Appendix 3: Peer Reviews and Evidence Statements

PROJECT VARIATION 1 TO THE PROPOSED DISTRICT PLAN: REZONING SUBMISSIONS
SUBJECT ROLLESTON PACKET: PEER REVIEW OF TRANSPORT MATTERS
TO JOCELYN LEWES; JUSTINE ASHLEY
FROM MAT COLLINS
DATE 28 MARCH 2023

V1-0025: 148 – 178 LINCOLN ROLLESTON ROAD, ROLLESTON, YOURSECTION LIMITED

V1-0084: 478 WEEDONS ROAD, ROLLESTON, APPLEFIELDS LIMITED

Figure 4: Rolleston East Plan Changes and rezoning requests, and realignment of the CRETS Collector for V1-0025

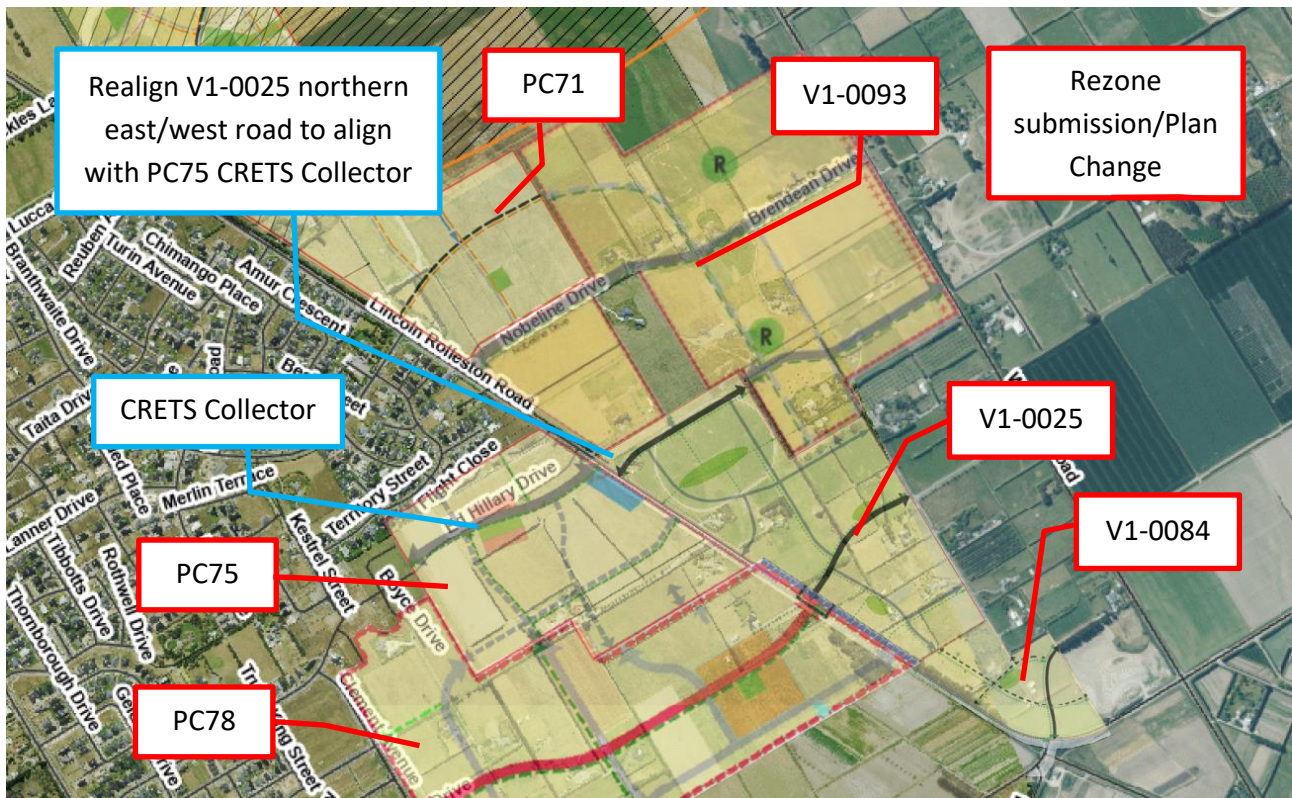
- ♦ The proposed transport network shown in the ODP generally aligns with the adjacent developments, however the northern east/west road should be moved north to align with Ed Hilary Drive (CRETS Collector) proposed by PC75. Refer to Figure 4

Figure 7: Concept design for the upgrade of Lincoln Rolleston Road / Selwyn Road intersection

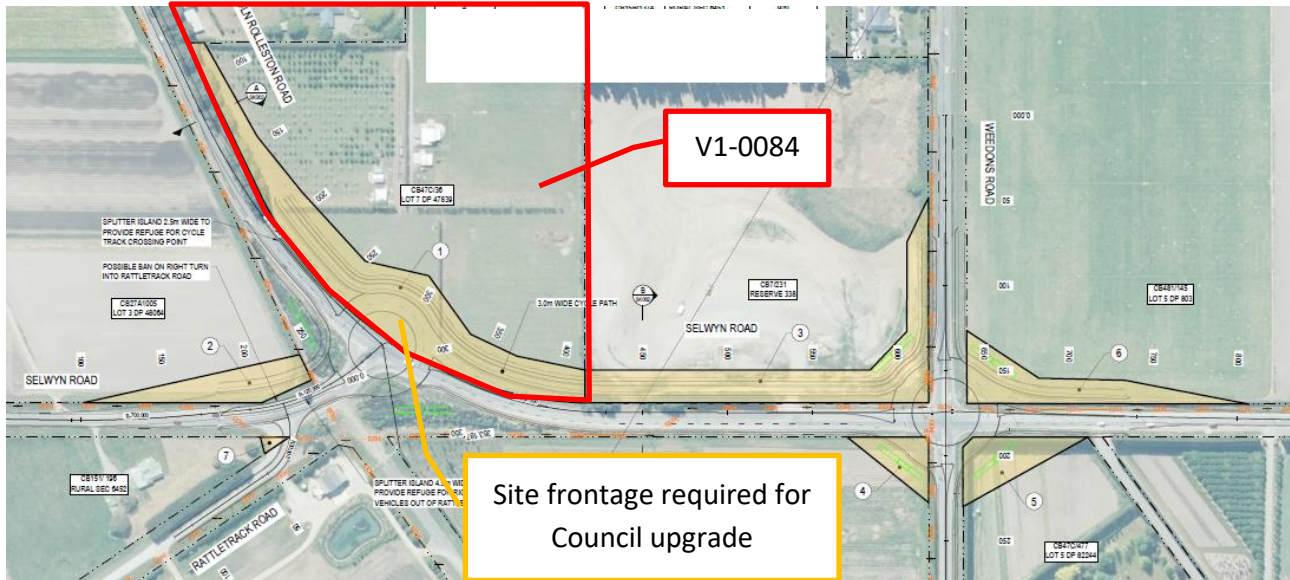
- ♦ I understand that Council intends to upgrade the Selwyn Road/Lincoln Rolleston Road intersection to a roundabout. This may require road widening within the site, the concept design produced by Council is shown in Figure 7

- ♦ However, the ODP does not indicate that this land may be required and therefore rezoning the site risks foreclosing Council's opportunity to upgrade the intersection. I recommend that the ODP indicate that site frontage may need to be vested to Council to allow the upgrade of the Selwyn Road/Lincoln Rolleston Road intersection, I note that this method was used for the SH1/Dunns Crossing Road in Plan Change 73³ and for the Dunns Crossing Road/Selwyn Road intersection in Plan Change 81⁴

Figure 9: V1-0084 ODP amendments

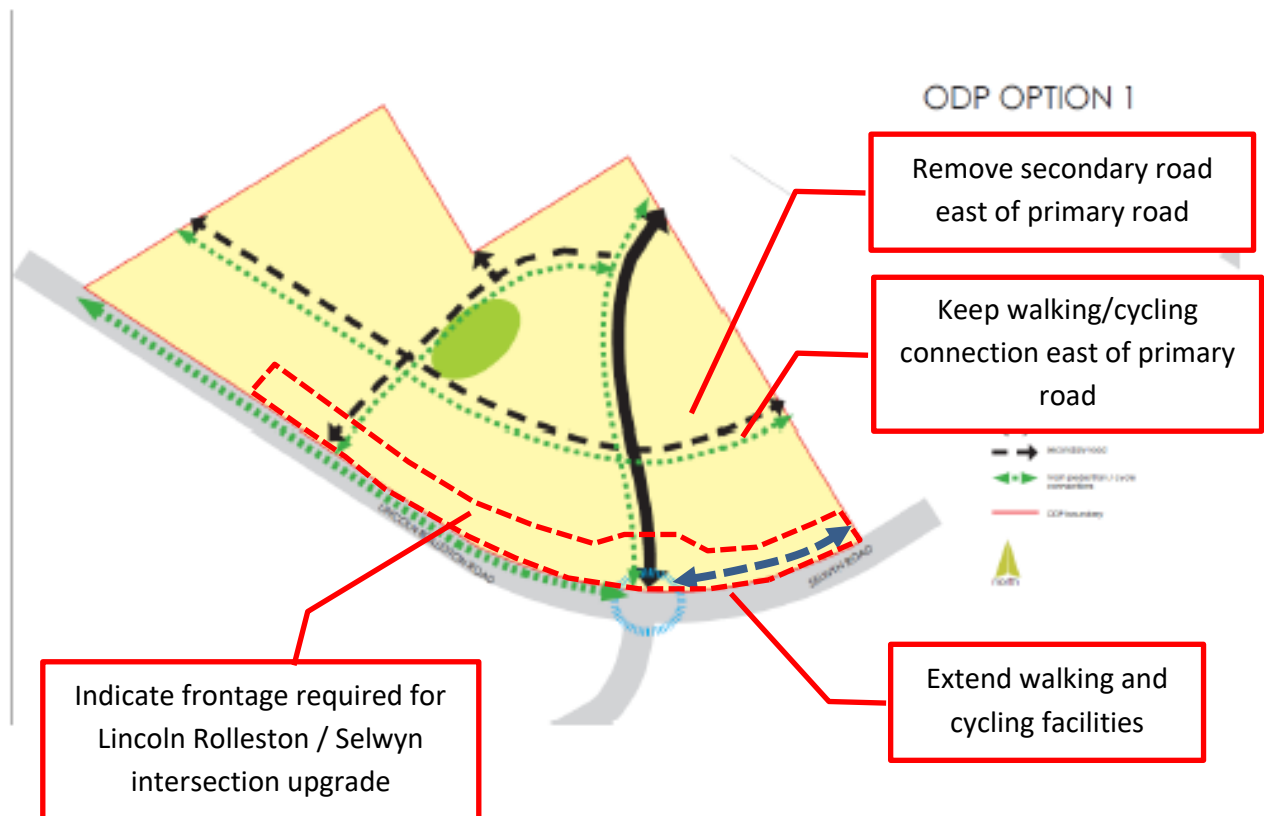
- ♦ I consider that the secondary east/west road should be deleted from the ODP, east of the primary north south road. The secondary east/west road is unlikely to be able to be extended as V1-0084 is adjacent to Reids Pit Park, as shown in Figure 8. I do not consider this connection to be critical to V1-0084 however I consider that the walking and cycling link that is shown on the ODP should be maintained

- indicate that full site frontage with Selwyn Road and Lincoln Rolleston Road be upgraded to urban standard, including footpath and cycle facilities
 - remove the secondary east/west road, east of the primary north south road (towards Reids Pit Park). However, the walking and cycling link along this route should be maintained. Refer to Figure 9.

Figure 12: Recommend amendments to the V1-0093 ODP

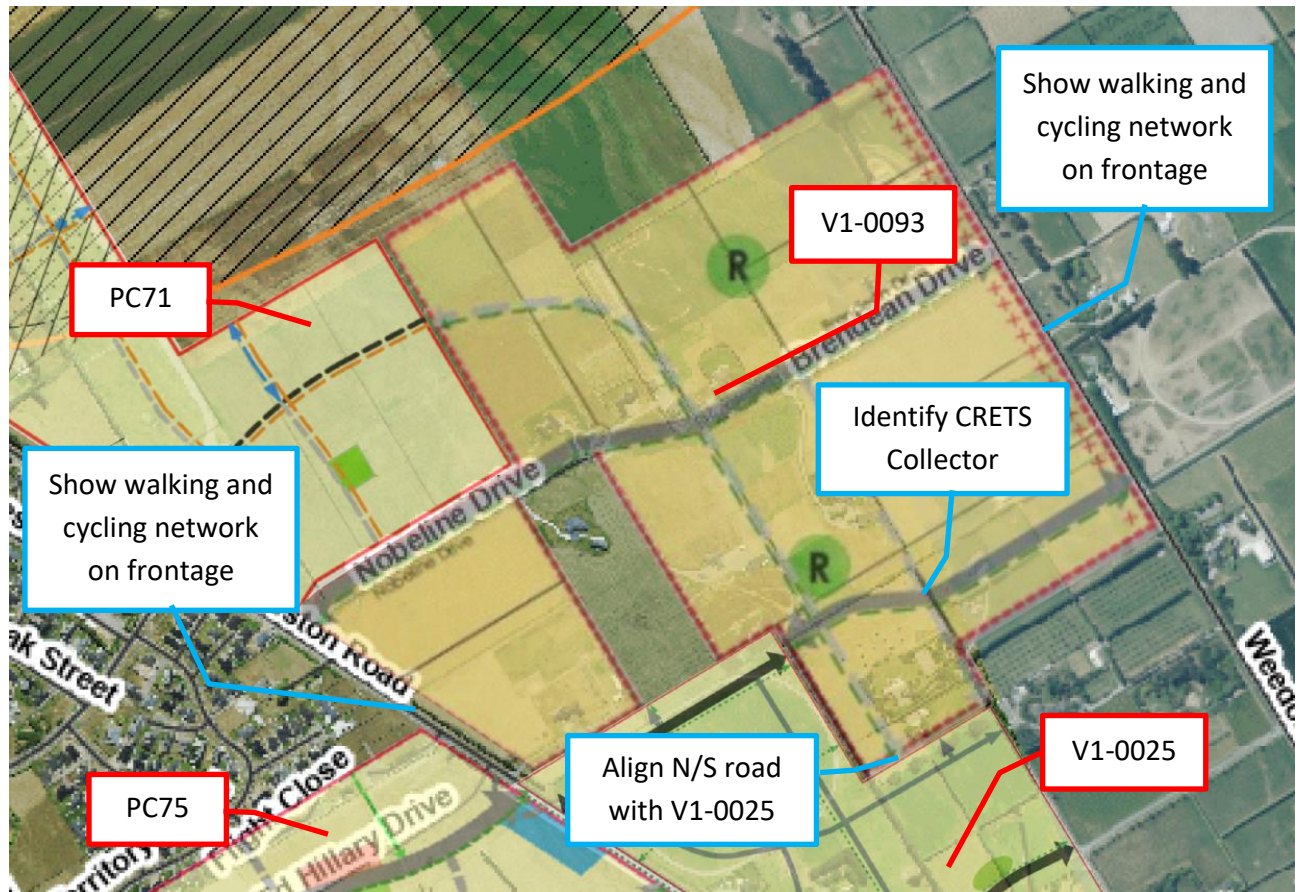
- ◆ Council rejects the rezoning request as there is insufficient information provided to assess the potential transport effects of the rezoning
- ◆ If the submitter provides additional assessment of transport effects, I recommend that this include consideration of several changes to the ODP to ensure consistency with adjacent Plan Changes and rezoning submissions, shown in Figure 12.

APPENDIX 1- RECOMMENDED AMENDMENTS TO ODP

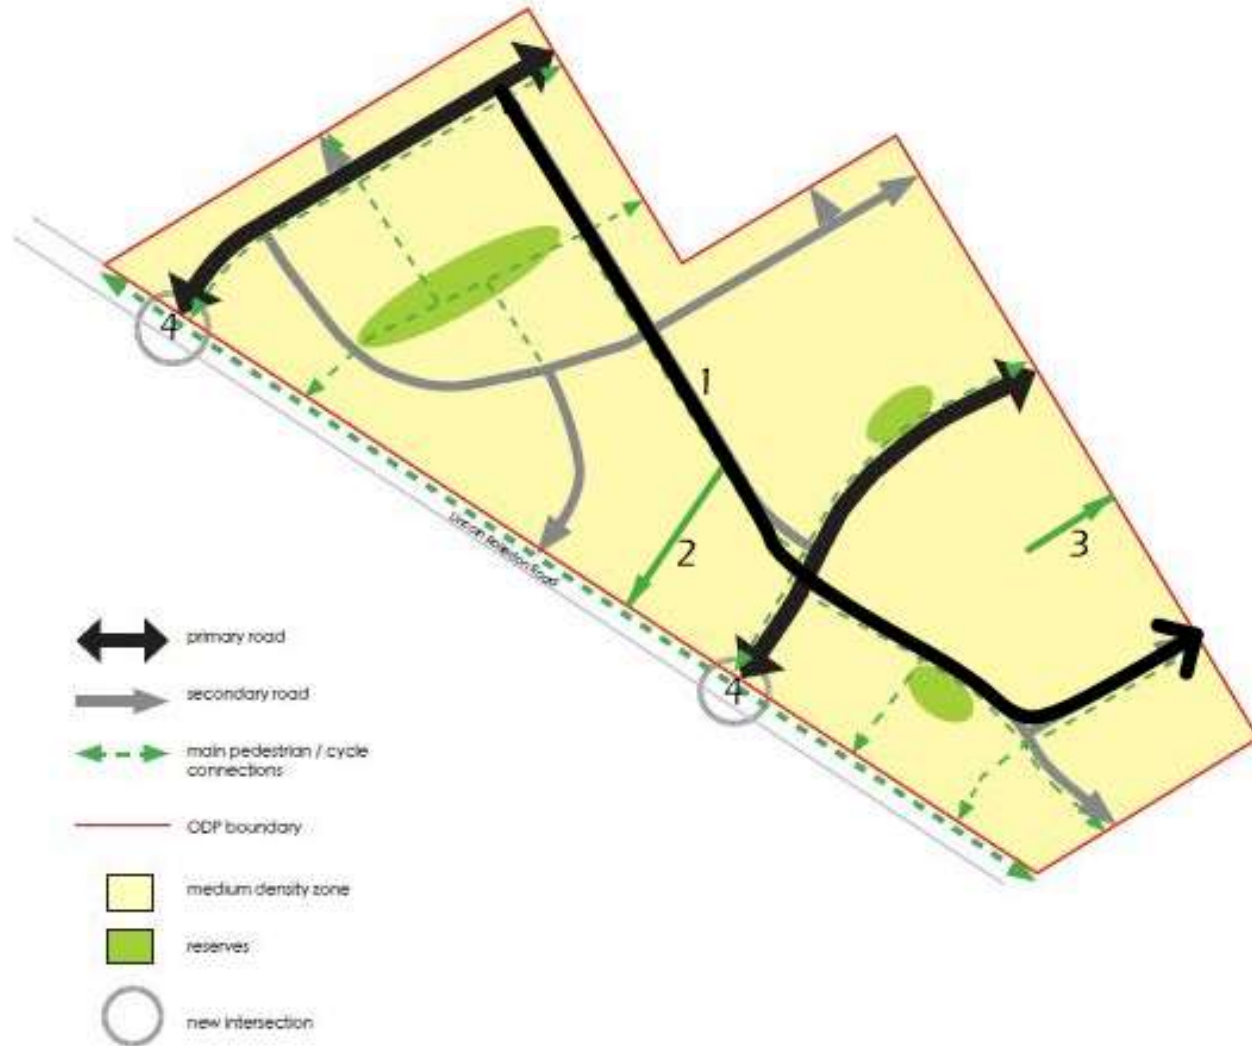
- a. If the rezoning request is considered favourable by the panel, I recommend making the following changes to the Outline Development Plan (illustrated in Figure 2 below, see also Appendix A):

1. **Change the secondary north-south internal spine road to a primary classification, reflecting the wider connectivity function of this road.**
 2. **Include a fourth pedestrian/cycle connection along Lincoln Rolleston Road to provide a better walkability within the development and to improve connectivity to adjacent neighbourhoods.**

3. **Include a pedestrian/cycle connection along the eastern boundary to provide a better walkability within the development and to improve connectivity to adjacent future neighbourhoods.**

Figure 2: Proposed changes (1-3) to the Outline Development Plan

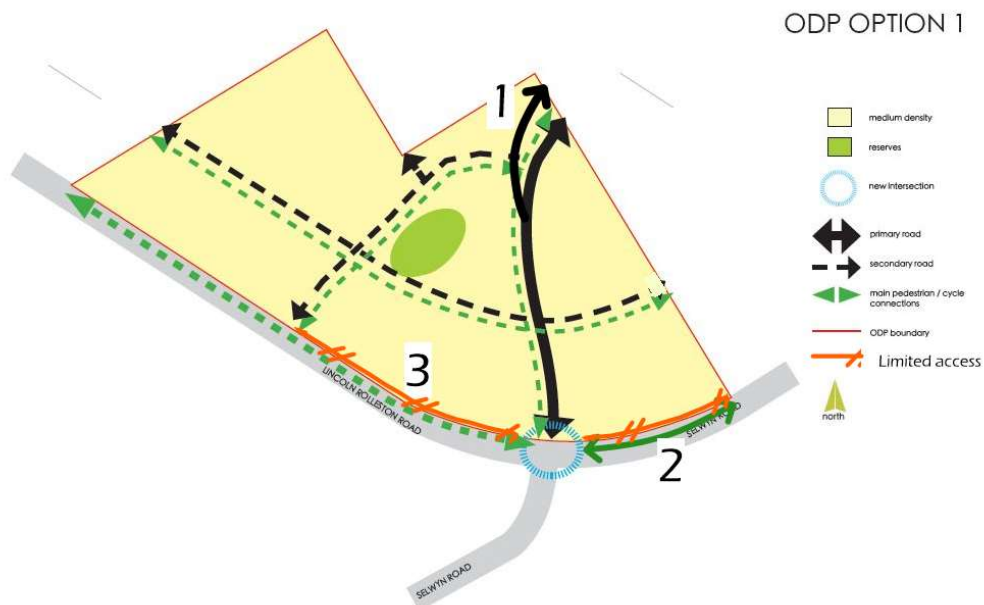
- a. I have reviewed the design concepts Option 1 and 2 and the design drivers for the proposed ODP layouts and consider Option 1 the preferred option in terms of alignment with the strategic future roading upgrades and overall achieving a better connectivity to adjoining development areas.
- b. If the rezoning request is considered favourable by the panel, I recommend making the following changes to the Outline Development Plan (illustrated in Figure 2 and Appendix A):

1. Change in alignment of the primary route to achieve a better overall north-south connection with adjoining future development areas.
 2. A continuation of the proposed pedestrian/cycle connection along Lincoln Rolleston Road to the extent of the boundary with Reids Pit (Council reserve).
 3. A notation on the ODP to limit access off Lincoln Rolleston Road for a portion of the site either side of the proposed future roundabout and major intersection for traffic safety reasons.
- c. For clarification I recommend making the following changes to the Outline Development Plan narrative:

Access and Circulation:

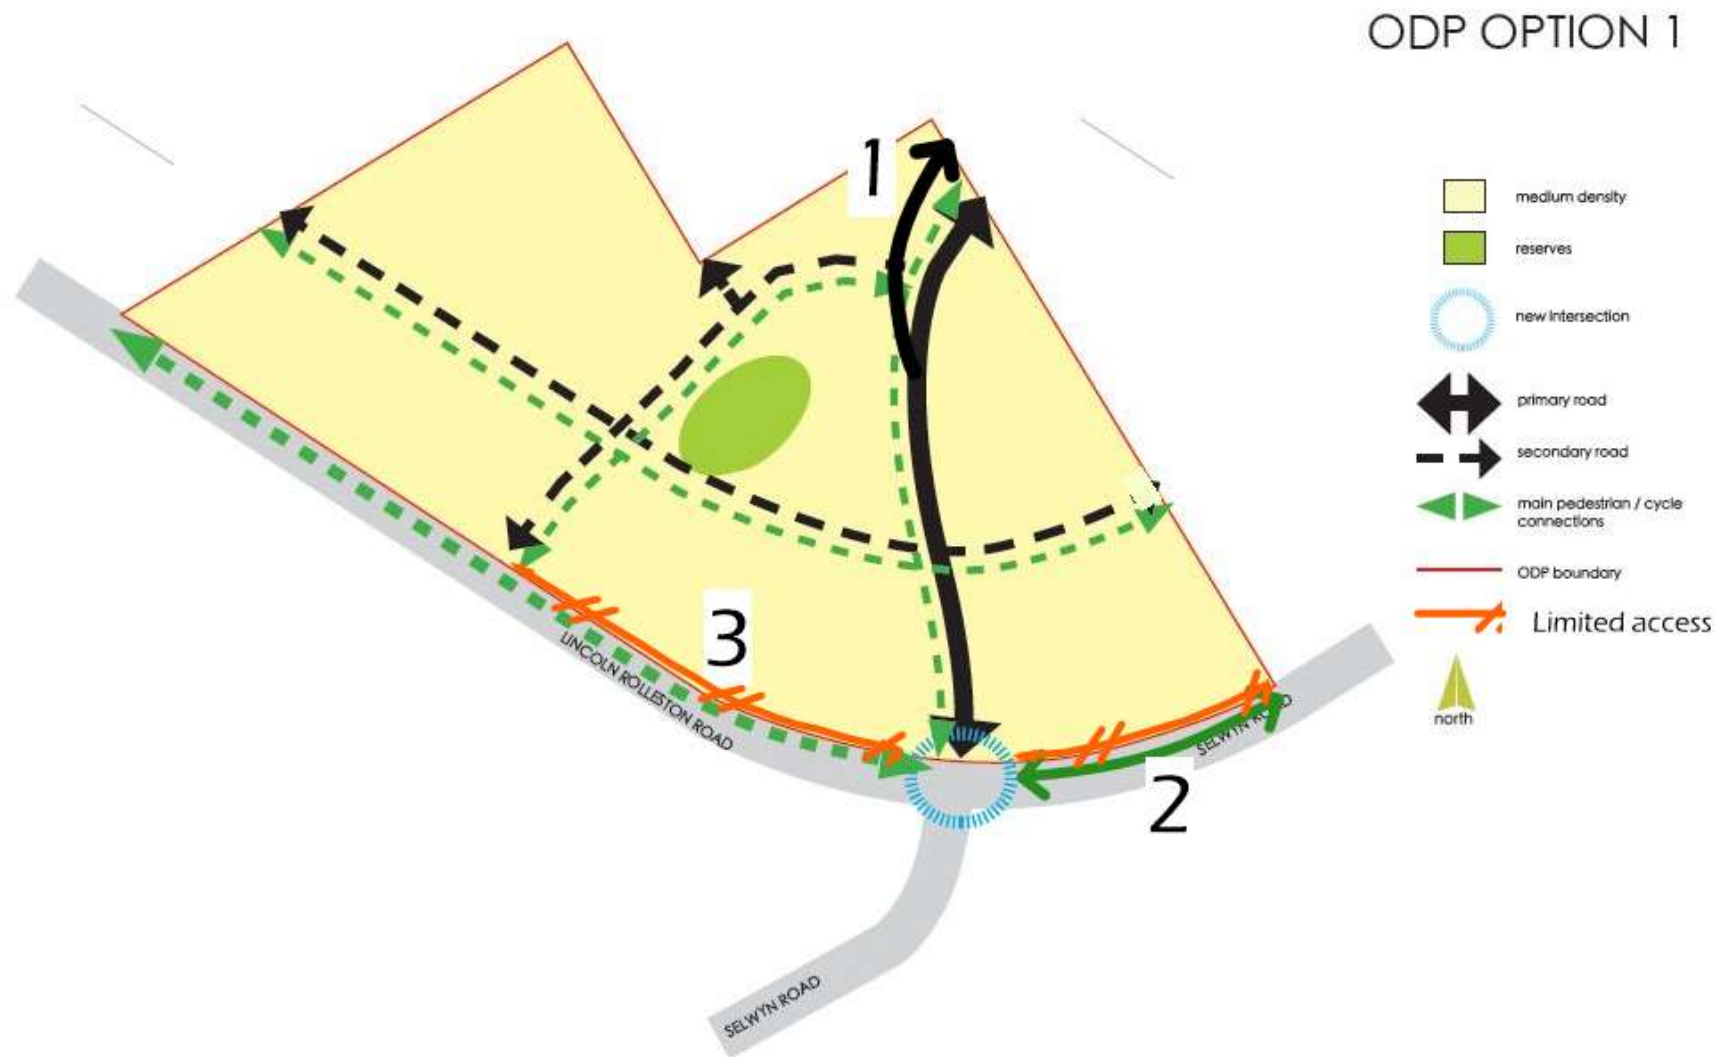
- 4. Remove sentence referring to two Outline Development Plan options and only refer to the chosen option.**
 - 5. Remove wording speculating on traffic volumes and speed.**

- 6. Amend wording of last sentence referring to properties along Lincoln Rolleston Road to be able to have direct property access, as follows: *"Properties outside area of limited access along Lincoln Rolleston Road will be able to have direct property access and contribute to an urban streetscape."***

- 7. Supplementary comment in the ODP narrative on the interface treatment along Lincoln Rolleston Road and function of the internal secondary spine road.**

- 8. Supplementary comment in the ODP narrative on the proposed interface with rural landuses, including potential reverse sensitivity issues with an existing poultry operation situated within 300m of the site.**
